STANDARDS AUSTRALIA/STANDARDS NEW ZEALAND

Amendment No. 1
to
AS/NZS 3010:2017
Electrical installations—Generating sets

REVISED TEXT

SUMMARY: This Amendment applies to Clauses 1.2, 1.3, 1.4.10, 2.2, 2.5, 2.6.3, 2.7.1, 2.8.2, 4.2.3 to 4.2.7 and 4.3.2.3 to 4.3.2.6, Table 2.1, Figures 2.3 to 2.16, and 4.1 to 4.3, and Appendices A, B, C and D.

Appendix B, Figure B2

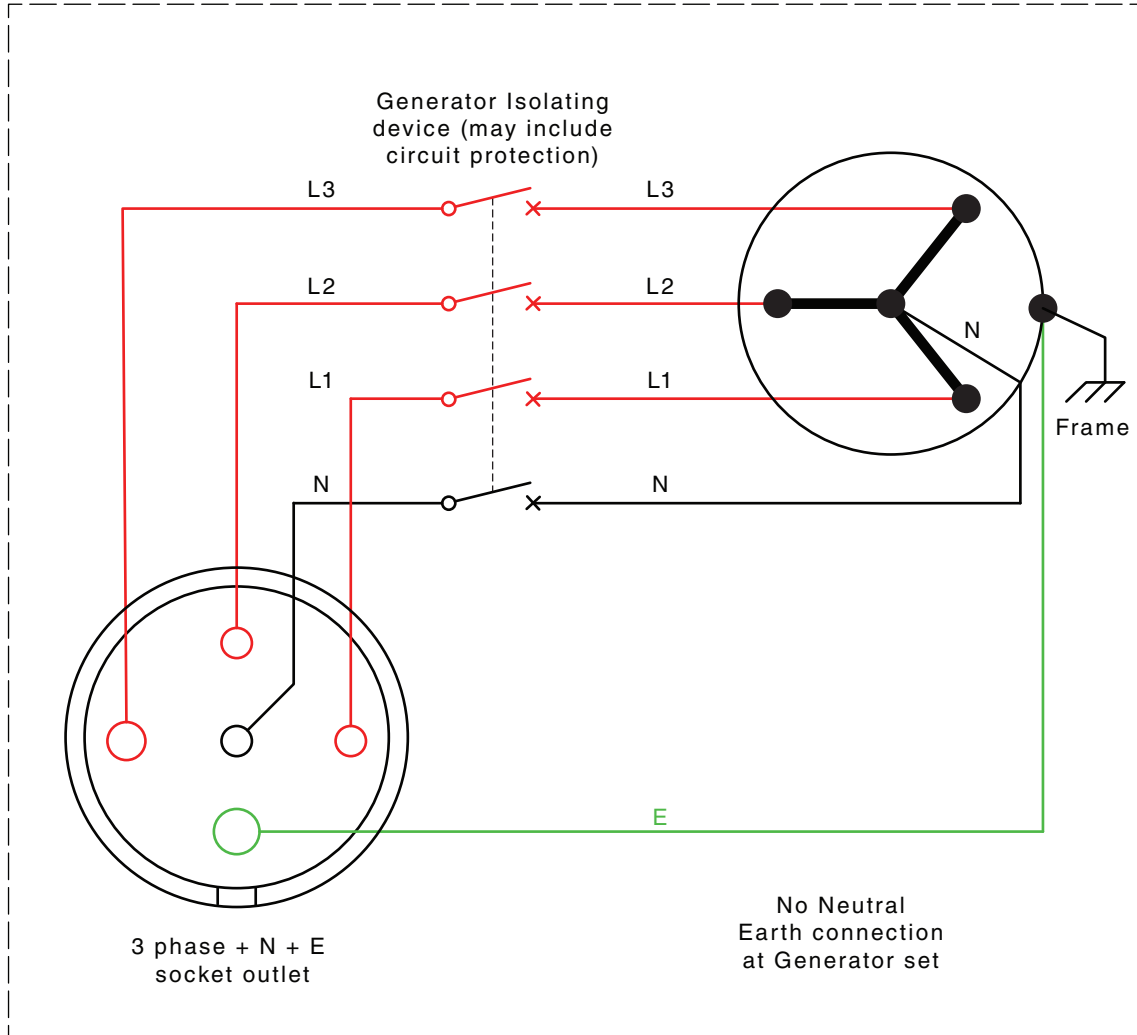
Replace the existing figure with the following:
